RAINBOW AIRCRAFT ADDRESS: Hangar 28, Springs Airfield, Dal Fouche, Springs, South Africa. Tel: 011 817 2298	SAFETY BULLETIN
NUMBER	TITLE
CH-11-08	Wing support strut brackets

Aircraft type	All Cheetah aircraft within serial number range identified below
Serial Nr	CH-088 through CH-097

ANNEX A

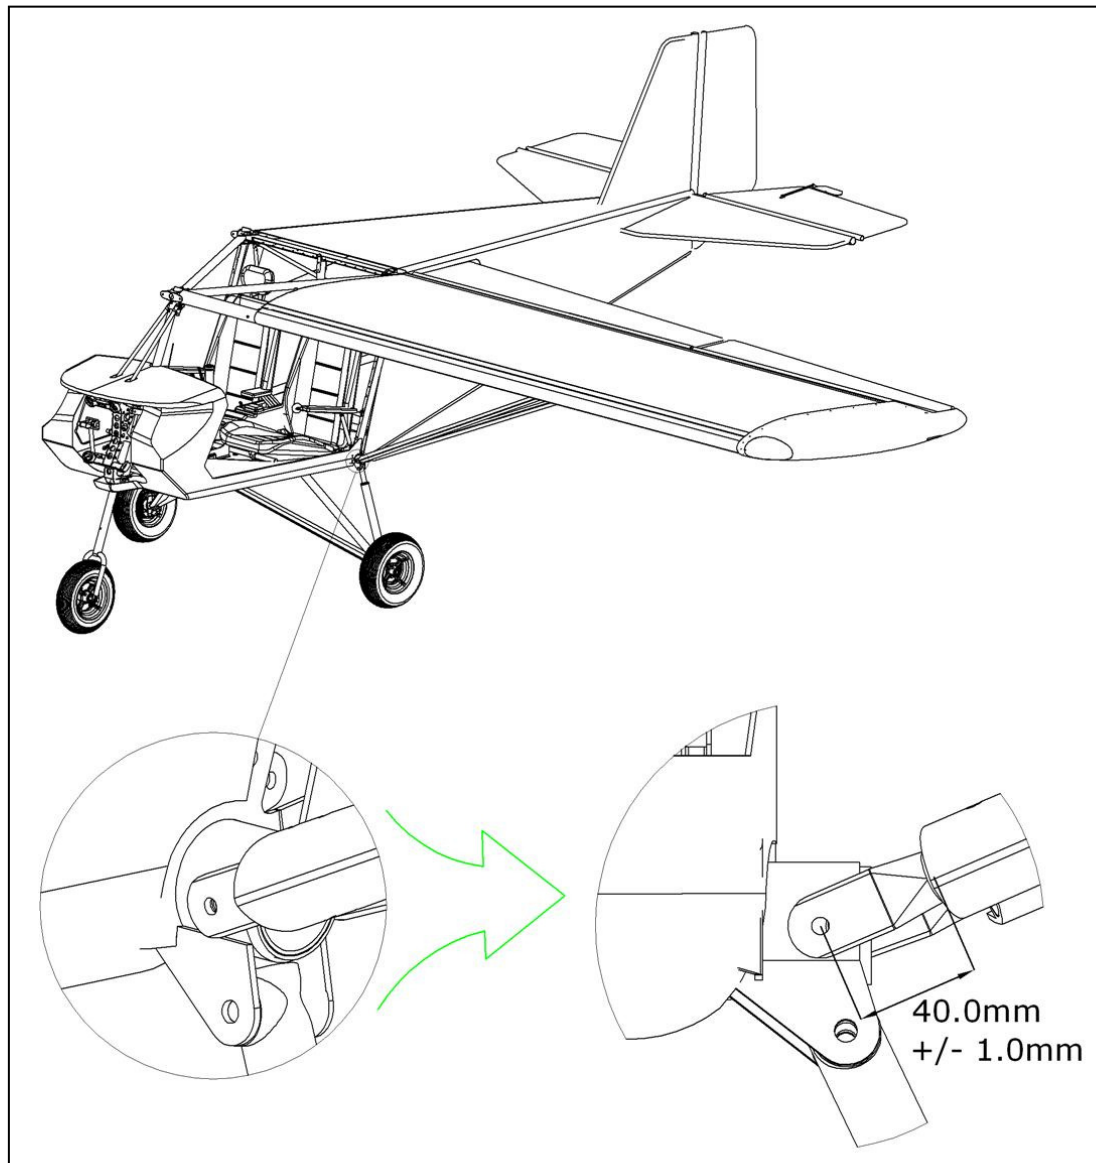
- 1) Inspect affected parts and ensure the distance as indicated in Annex A is correct.
- 2) Only Front Wing Support Strut tubes may be affected, on Left and Right hand sides.
- 3) If indicated distance is out of spec contact the factory to make arrangement for replacement of affected components.
- 4) Replacement of this part must be done by factory personnel only.

Note: Measure the distance from the centre of the Front wing strut mounting bolt to the edge of the wing strut. The distance should be 40.0mm +/- 1.0mm.
